SABIA, Inc.
7944 Convoy Court
San Diego, CA 92111
(858)279-4000
jmiller@sabiainc.com

September 27, 2004

United States Nuclear Regulatory Commission
Materials Safety Branch
Division of Industrial Safety and Material Nuclear Safety
Two White Flint North
11545 Rockville Pike
Rockville, MD 20852
Attention: Mr. Xiasong Yin

Reference: Your letter and Fax of September 7, 2004

600167 Source Sled

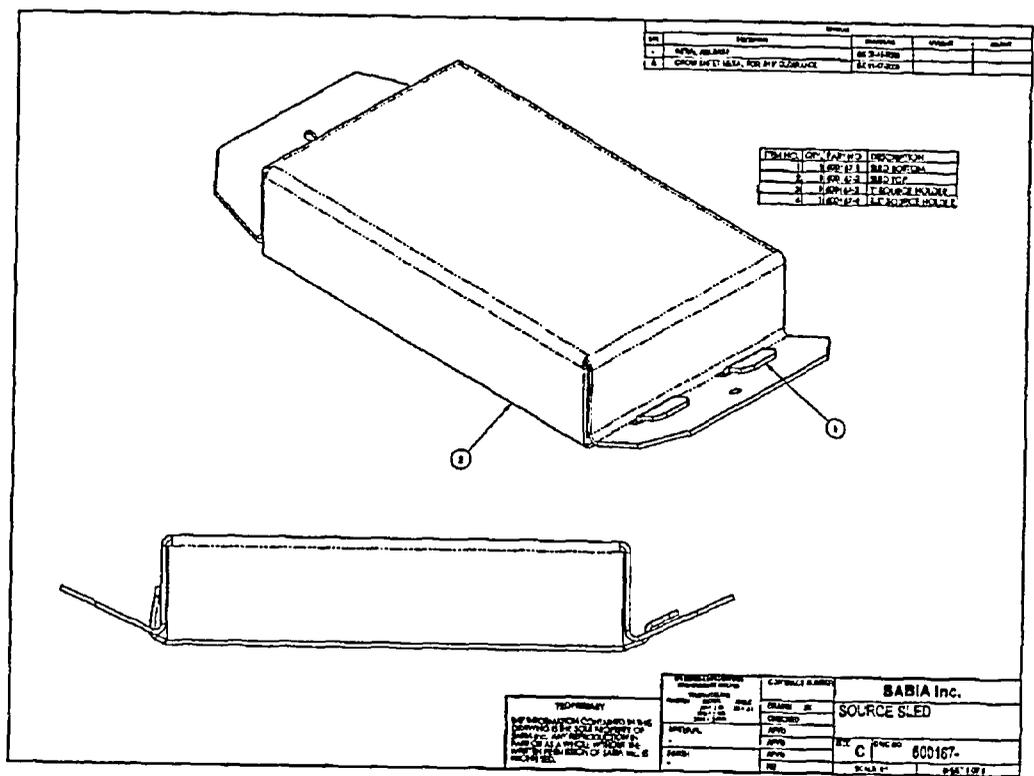
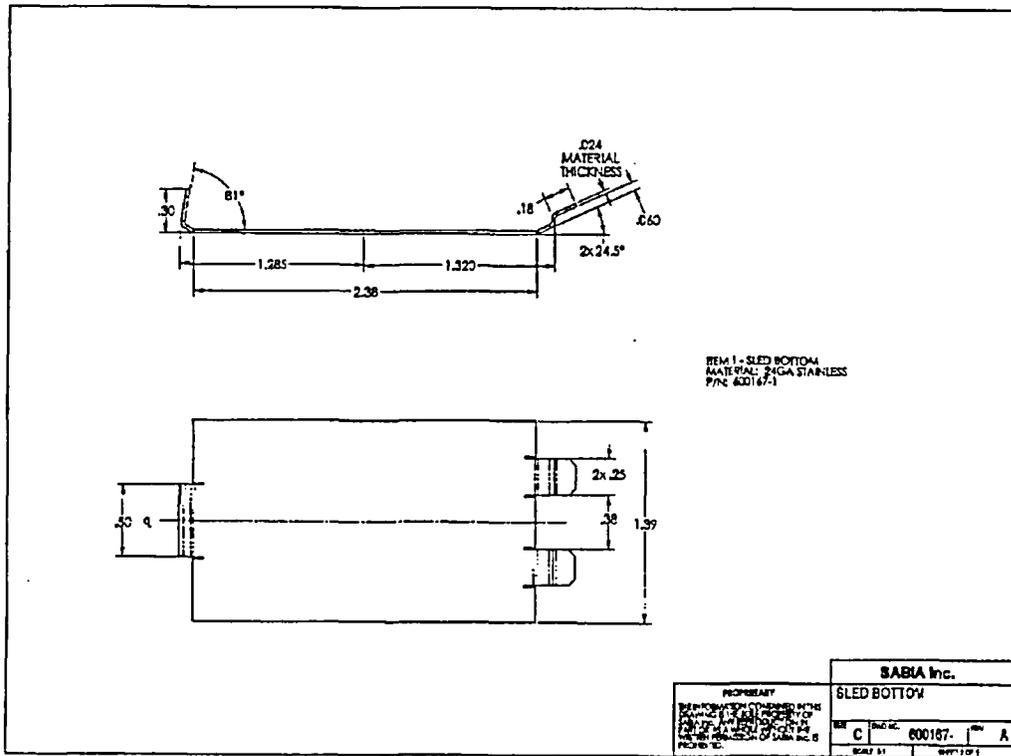
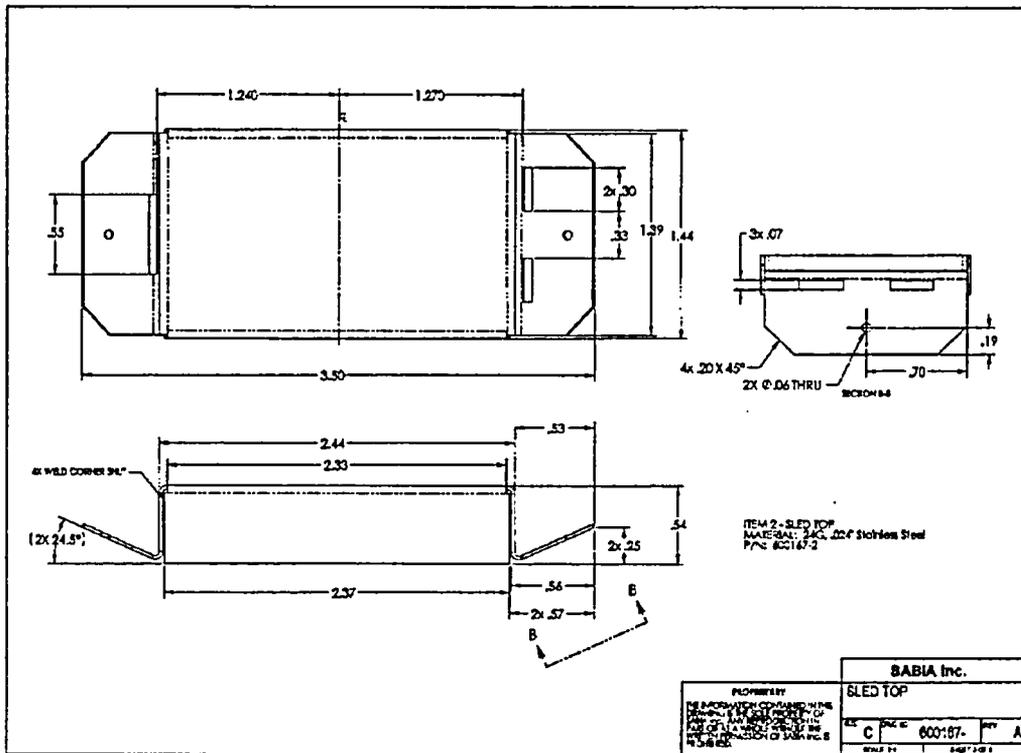
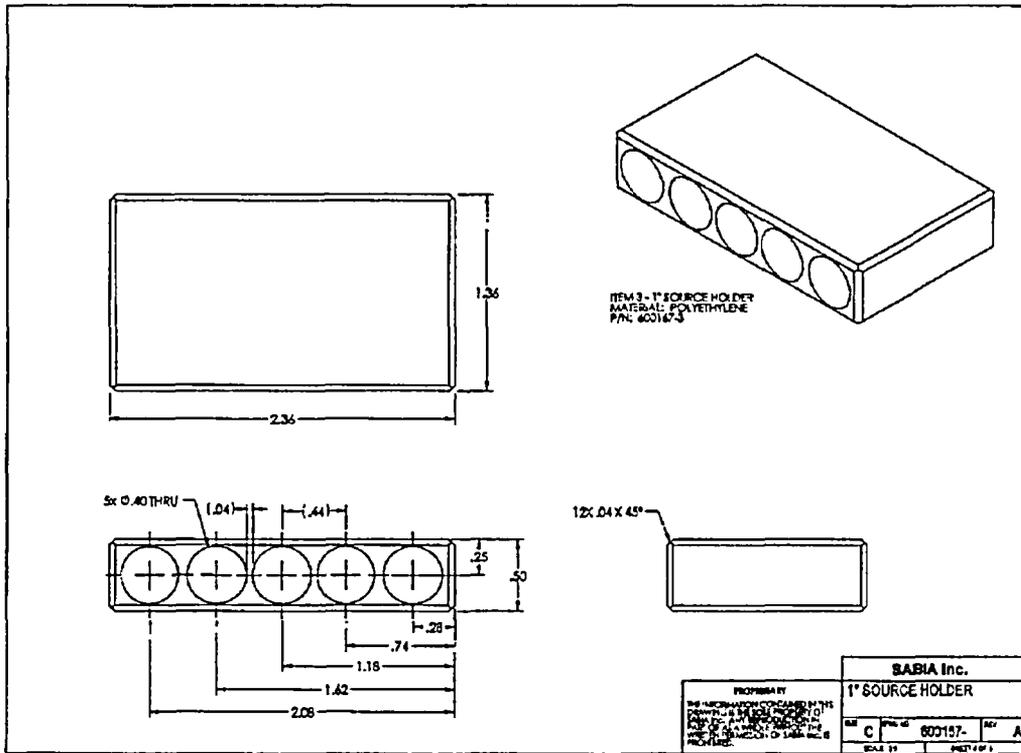
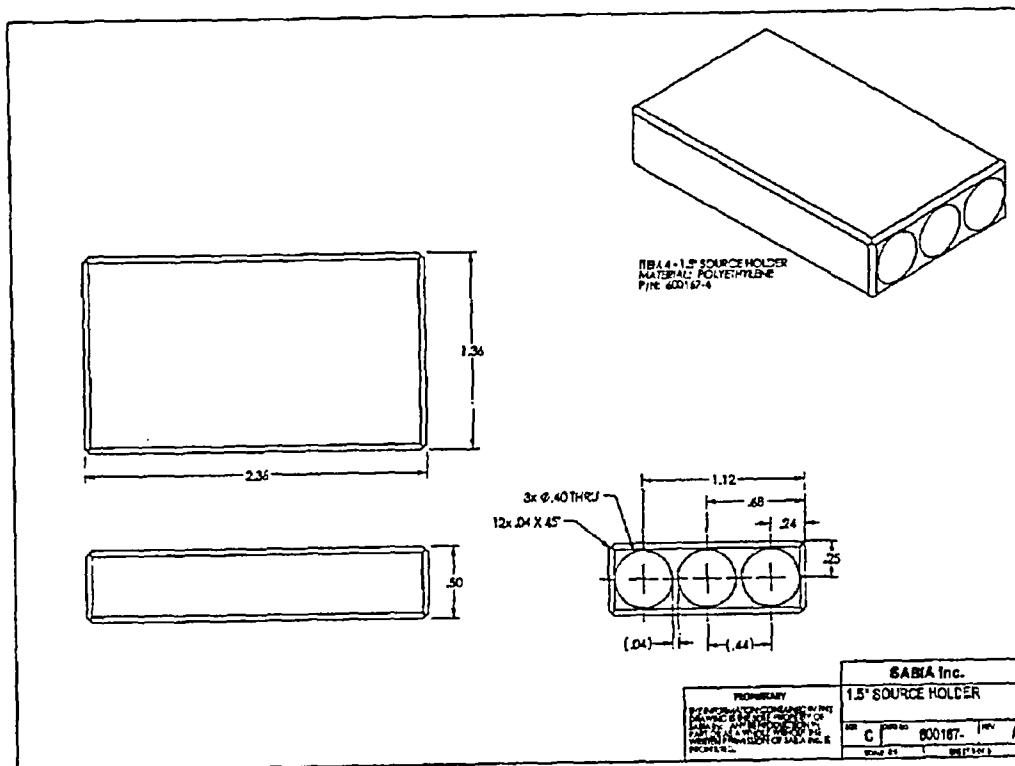
2.1 In reference to NUREG 1556, Vol. 3, Section 10.3, the SABIA drawing 600167 "Source Sled" is a detail drawing of the Source Holder as described in the NUREG. If the Frontier Model 100 series source is used, the part shown in drawing 600167-4 provides the support and mounting of the sources into the overall source holder. This provides for a maximum of 3 sources in each source holder. If the Frontier Model 100S series source is used, 600167-3 shows the support and mounting for the sources into the overall source holder. This provides for a maximum of 5 sources in each source holder.

2.4 Drawing 600167 shows the source holder. The title of the drawing is "Source Sled". This is the source holder, as defined in NUREG-1556, Vol. 3. The Source Sled is attached to the two ends of the stainless steel cable and placed into the end of the path assembly. The stainless steel cable is attached to the wheel as shown in Figure A. Mechanical stops are inserted into the top and bottom of the path assembly, and the final position adjustments for the precise location of the "Source Sled" are made for the indicator handle. When sources are installed or wiped, that is done as outlined in the attached procedure which outlines the steps necessary to access the source holder assembly for periodic source wipe testing, for source replacement, and for adjustment of the source position within the source housing.

c. The sources have an outside diameter of 0.375 inches. The holders (spacers), 600167-3 and 600167-4, have a hole diameter of 0.40 inches. The sources are slipped into these holes. This holder, which acts as a spacer within the source sled, is then inserted into the Source Sled, which is fastened closed, securing the sources. The Source Sled is then held in proper position by the stainless steel cable. The stainless steel cable is marine grade and is coated with nylon to minimize fraying and corrosion in salt spray. It attaches to both ends of the source holder (sled); therefore, if the wire were separated from the sled in one direction, it could be removed by pulling the cable in the other direction. If the cable were separated from the sled on both sides, the sled could be easily pushed out through its track with a flexible rod. Though the probability of the cable failing is small and of its failing two times simultaneously is extremely small, even that unlikely event would not be a problem.
